RE: RESPONSE TO INFORMATION REQUEST
215 LANCASTER ROAD, ASCOT QLD 4007

In accordance with s13.2 of the Development Assessment Rules, a full response to the Information Request that was issued by the Brisbane City Council (the **Council**) on 4 March 2026 is provided below.

Figure A – Proposed Commercial Bin Storage Area

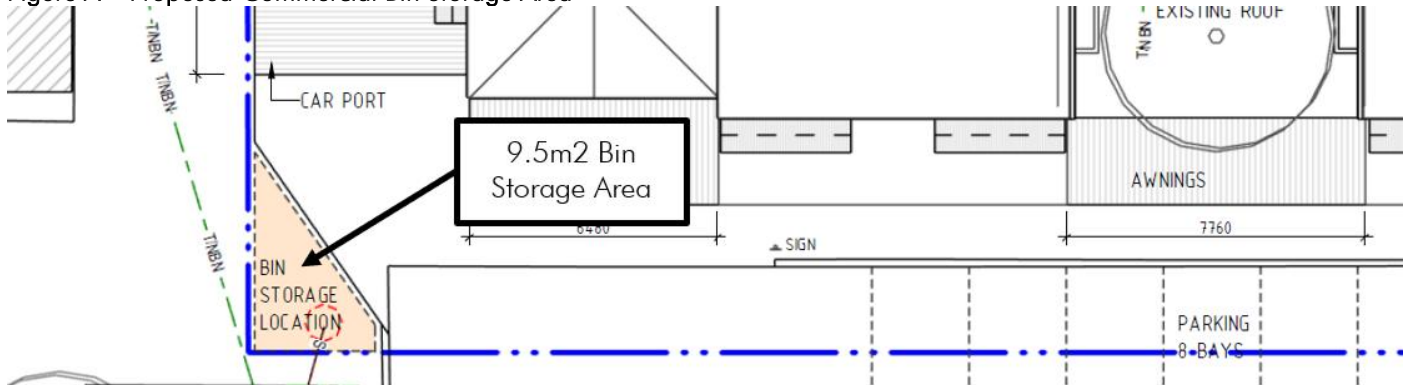
It is noted that one (1) 'Bin storage location' has been shown on the proposed plan. However, the 'Bin storage location' is not denoted as roofed and wholly screened and the triangular design and configuration does not provide sufficient storage, capacity, and source separation to cater for the commercial and residential units. To improve the amenity outcomes for the adjoining sensitive use lot, reduce the visual impact from the public realm and ensure separation of commercial and residential waste, demonstrate the following:

- a) In accordance with AO63.1 and AO63.2/PO63 of the Centre or mixed use code, AO8.1 and AO8.2/PO8 of the Infrastructure design code and AO15.1 and AO15.2/PO15 of the Small-scale non-residential uses code, provide amended architectural plans which shows a separate refuse storage location for the developments commercial refuse room (within a building) or refuse enclosure (roofed and fully screened) with a minimum GFA of 9m² (internal dimension of 3m x 3m).

As requested by the Council, the development features a dedicated commercial bin storage area measuring 9.5m² (refer **Figure A**). An appropriate number of bulk bins, fitted with wheels, can be stored within the commercial bin storage area. The Council may impose a relevant condition of approval requiring the bin storage area to be roofed and screened.
